National Electricity Amendment (Technical Standards for Wind Generation and other Generator Connections) Rule 2007

National Electricity Amendment (Technical Standards for Wind Generation and other Generator Connections) Rule 2007

Schedule 1 Amendment of National Electricity Rules

Figure S5.1a.1

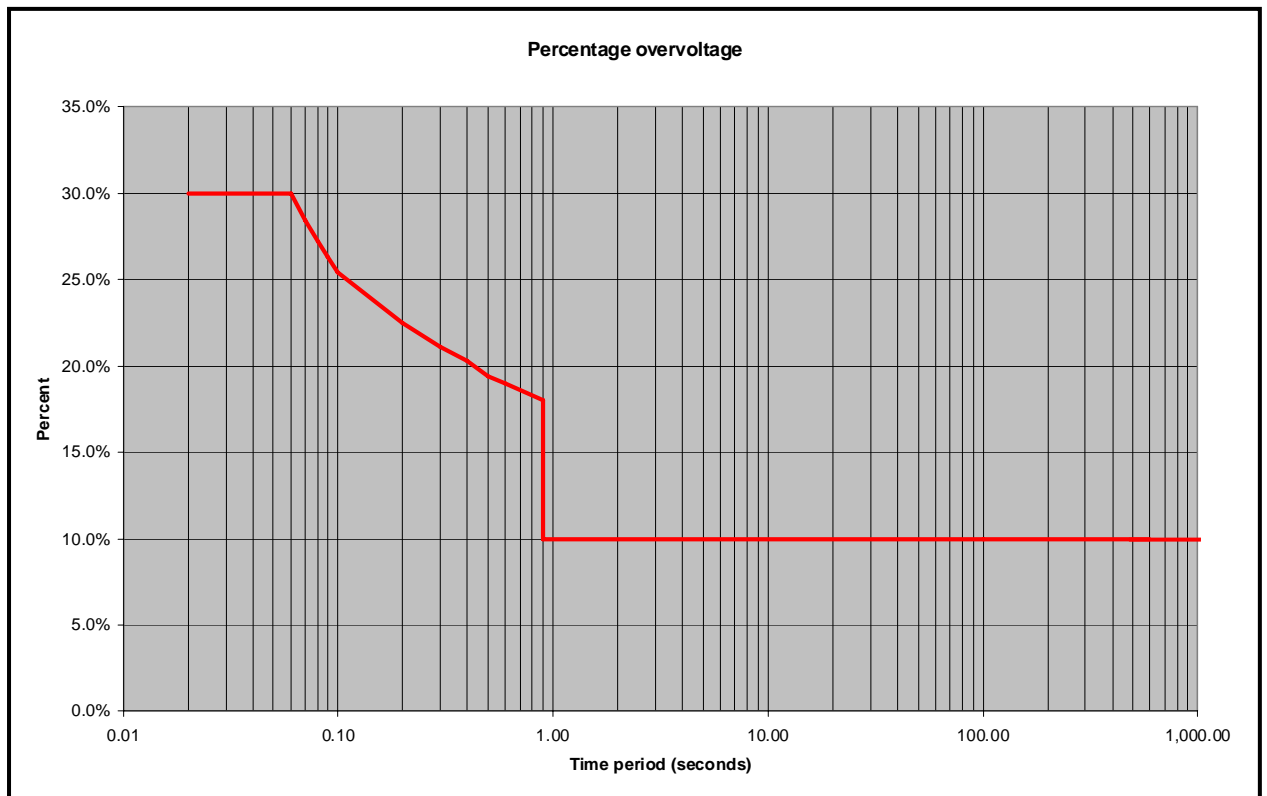
Omit clause S5.1a.4 including the diagram numbered Figure S5.1a.1 and substitute:

As a consequence of a *credible contingency event*, the *voltage of supply* at a *connection point* should not rise above its *normal voltage* by more than a given percentage of *normal voltage* for longer than the corresponding period shown in Figure S5.1a.1 for that percentage.

As a consequence of a *contingency event*, the *voltage of supply* at a *connection point* could fall to zero for any period.
